## Riley Purgatory Bluff Creek Watershed District Permit Application Review

**Permit No:** 2023-005

**Project:** Sunnybrook Road Culvert and Storm Sewer Improvements – The proposed project includes replacement of an existing 24-inch culvert under Sunnybrook Road in the vicinity of Homeward Hills Road in Eden Prairie. The culvert is in the Purgatory Creek watershed and connects two wetlands: 23-34-A, a public water wetland, on the upstream end and 23-34-B on the downstream end.

**Reviewer:** Scott Sobiech, PE, Barr Engineering

**Photos of heaving pavement over culvert crossing**

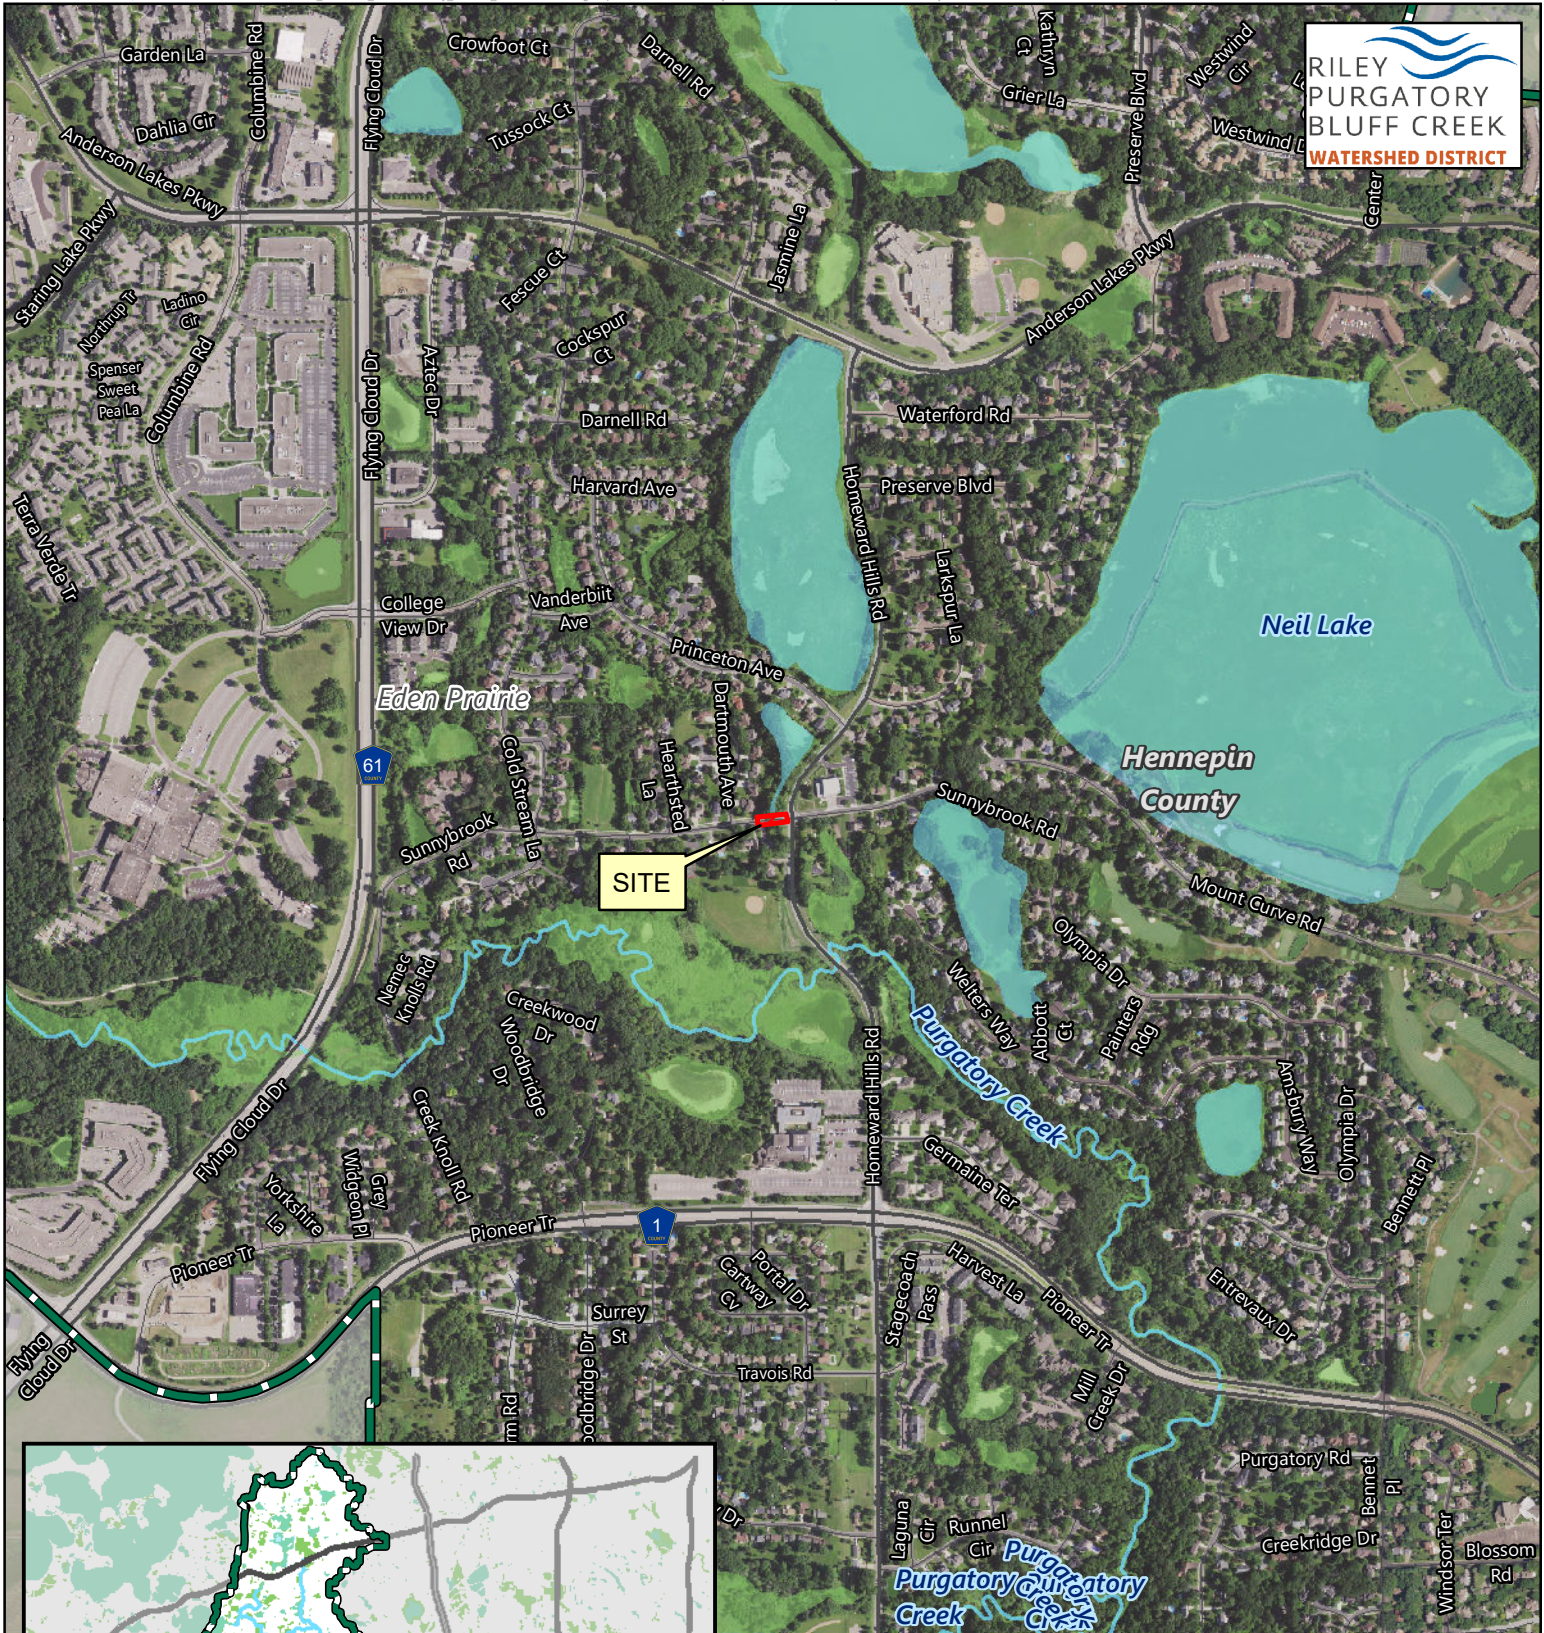
This work represents a public benefit by replacing an existing culvert that is susceptible to heaving leading to disruption along the public roadway (shown in photos below). In addition, the project involves the repair of deteriorating public infrastructure (Rule G, Subsection 3.1a and 3.1b).

CITY OF EDEN PRAIRIE  
SUNNYBROOK CULVERT REPLACEMENT & ADA PEDESTRIAN RAMP PROJECT  
EROSION CONTROL & GENERAL NOTES, SEQ & DETAILS

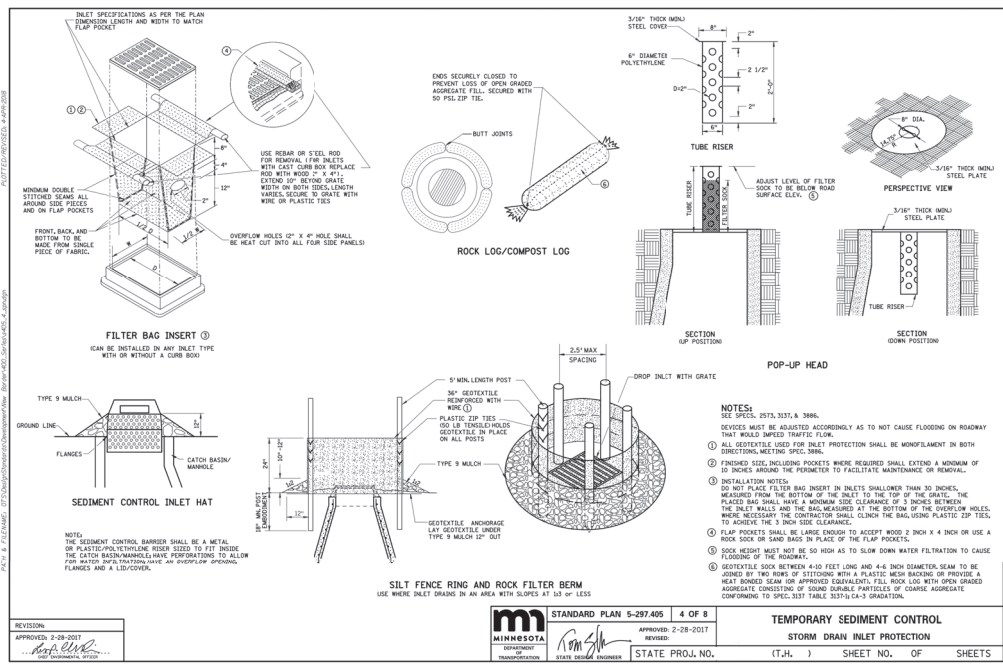
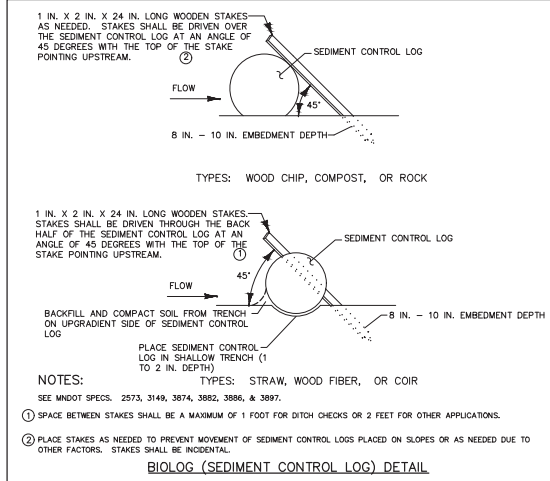
- G1. A note must be added to the Erosion Control & General Notes, Seq & Details sheet requiring no activity conducted between March 15 and June 15. (Rule G, subsection 3.7a.)
- G2. RPBCWD and Eden Prairie have entered into a programmatic maintenance agreement covering city projects subject to RPBCWD regulatory requirements. The waterbody crossing associated with this permit (2023-005) must be incorporated into the inventory of those managed in accordance with the programmatic agreement as a condition of approval.

CITY OF EDEN PRAIRIE  
 SUNNYBROOK CULVERT REPLACEMENT & ADA PEDESTRIAN RAMP PROJECT  
 STORM SEWER PLAN AND EROSION CONTROL PLAN

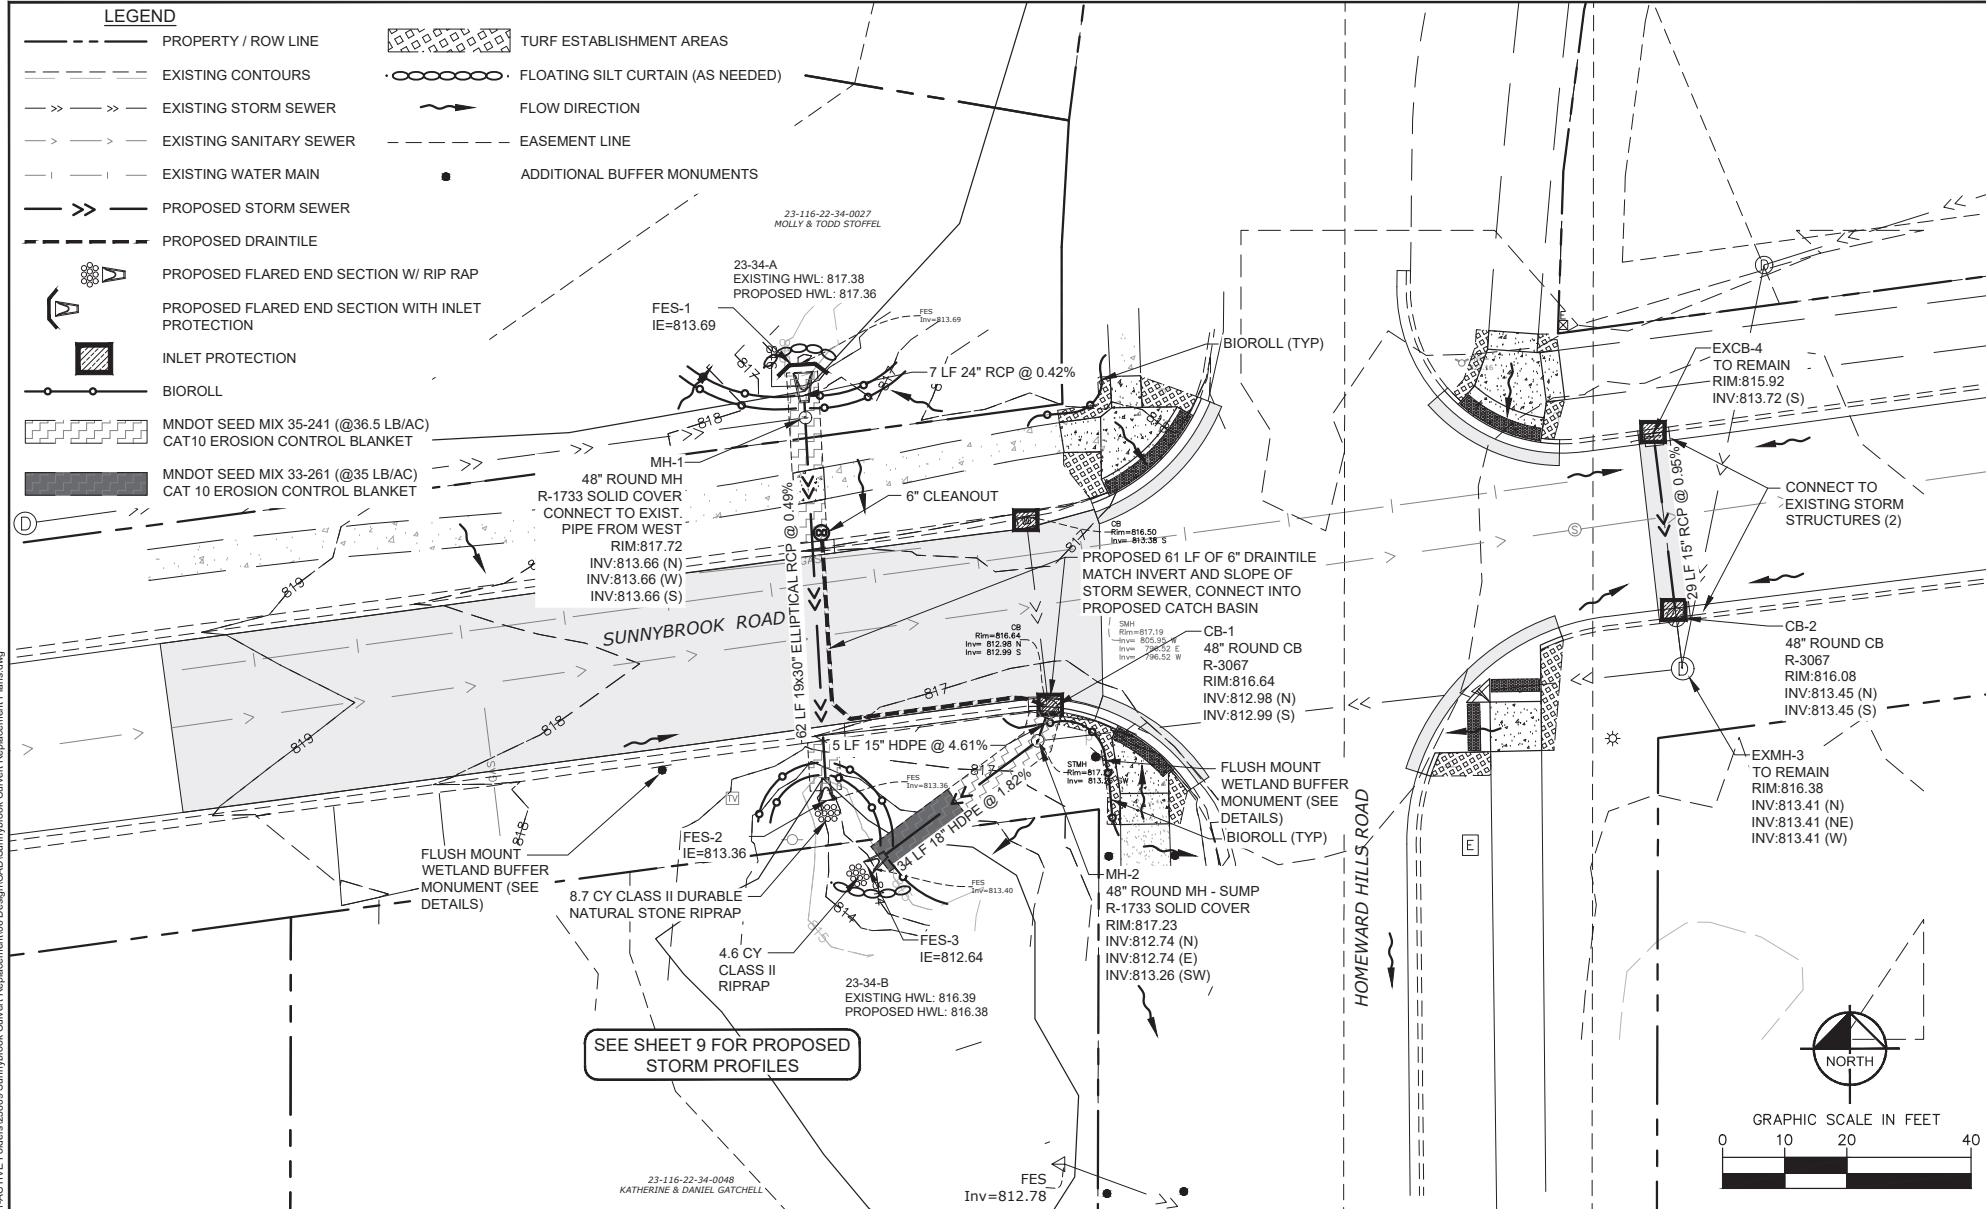
The section of culvert that discharges to 23-34-B is being replaced with a 30-inch wide elliptical RCP resulting in permanent wetland impacts to 23-34-B due to the increased footprint of the pipe. Because Wetland 23-34-B (a medium value wetland) is disturbed by the proposed work, a wetland buffer is required around the entire wetland (Rule D, subsection 3.1.a) on property owned by the city (Rule D, subsection 3.2f). An average buffer width of 40 feet and a minimum buffer width of 20 feet is required in accordance with Rule D, Subsection 3.2.a.iii but limited in width to the extent of available right-of-way (ROW) (Rule D, Subsection 3.2g). The buffer widths are summarized in the following table

The Applicant provided buffer zone and marker location information on the construction drawings confirming that the proposed buffer area extends to the right-of-way limits in conformance with Rule D, subsection 3.2g. The storm sewer and erosion control plan require revegetating disturbed areas within the proposed buffer with native vegetation and show wetland buffer marker locations which conforms with Rule D, Subsection 3.3. A note is included on the plan sheet indicating the project will be constructed so as to minimize the potential transfer of aquatic invasive species (e.g., zebra mussels, Eurasian watermilfoil, etc.) to the maximum extent possible conforming to Rule D, Subsection 3.5.

D1. Buffer areas and maintenance requirements must be documented in an agreement after review and approval by RPBCWD in accordance with Rule D, Subsection 3.5. RPBCWD and Eden Prairie have entered into a programmatic maintenance agreement covering city projects subject to RPBCWD regulatory requirements. The buffers associated with this permit (2023-005) must be incorporated into the inventory of those managed in accordance with the programmatic agreement as a condition of approval.
